**COLORADO DIVISION OF RECLAMATION, MINING AND SAFETY
MINERALS PROGRAM INSPECTION REPORT****PHONE: (303) 866-3567**

MINE NAME: Liberty Project	MINE/PROSPECTING ID#: P-2007-058	MINERAL: Gold	COUNTY: Ouray
INSPECTION TYPE: Monitoring	INSPECTOR(S): Lucas West	INSP. DATE: October 2, 2019	INSP. TIME: 10:30
OPERATOR: The Mining Company, Inc.	OPERATOR REPRESENTATIVE: None	TYPE OF OPERATION: MP - Mineral Prospecting

Photo Two: View south showing the secured portal gate. Also visible is the approximately 3 foot deep mine pool. Original Application documents indicate that no mine pool would be present.

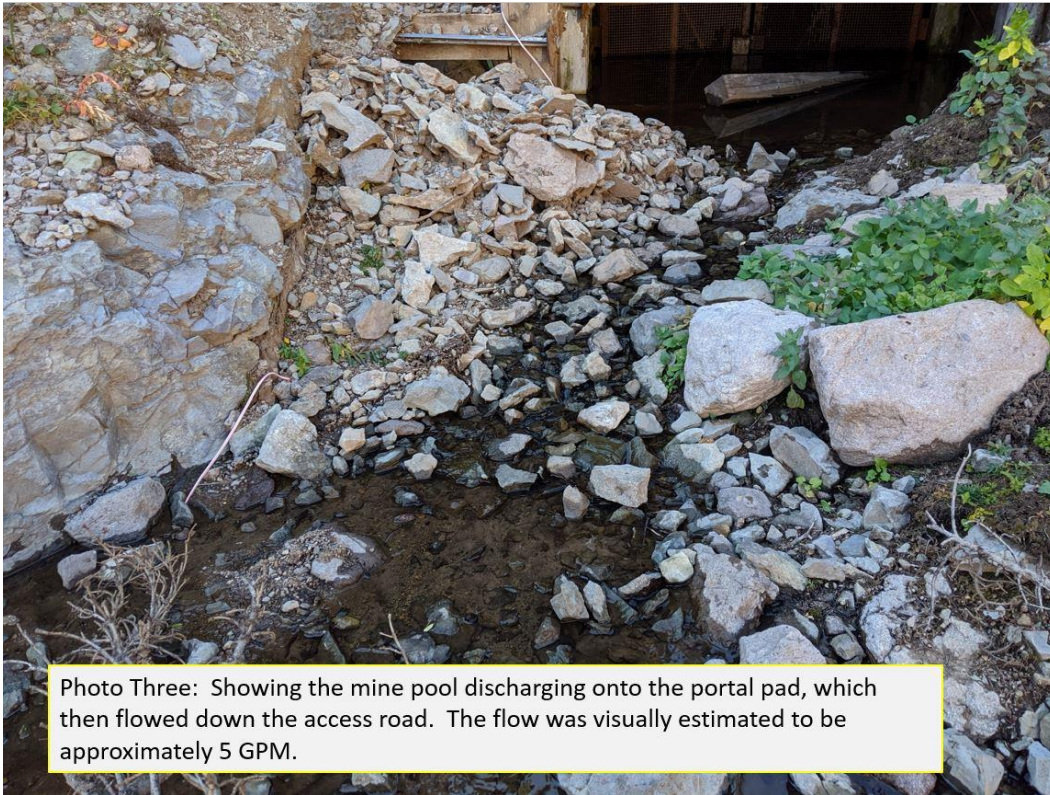
Unauthorized portal discharge. During the site inspection September 11, 2019 and October 2, 2019 water was observed discharging the portal, traveling down the access road. The Mining and Reclamation plan outline that the mine does not have a mine pool and there is no discharge associated with the Notice. Within 30 days of the date of this report, the Operator shall submit a written explanation of the presence of water in the mine. The Explanation should be submitted no later than Friday November 29, 2019. The Operator shall also conduct a study to investigate the source and perform a basic water quality analysis, submitting the results to the Division. Due to winter conditions the results of the study should be submitted after the 2020 run off season, no later than Monday June 1, 2020. The discharge can be seen in Photo Three. The results of the corrective actions may result in further action being necessary.

CORRECTIVE ACTIONS: Within 30 days of the date of this report, The Operator shall submit an explanation of the presence of water in the mine. The explanation should be received no later than Friday November 29, 2019. Also the Operator shall conduct a study to investigate the source and perform a basic water quality analysis, submitting the results to the Division after the runoff season no later than June 1, 2020.
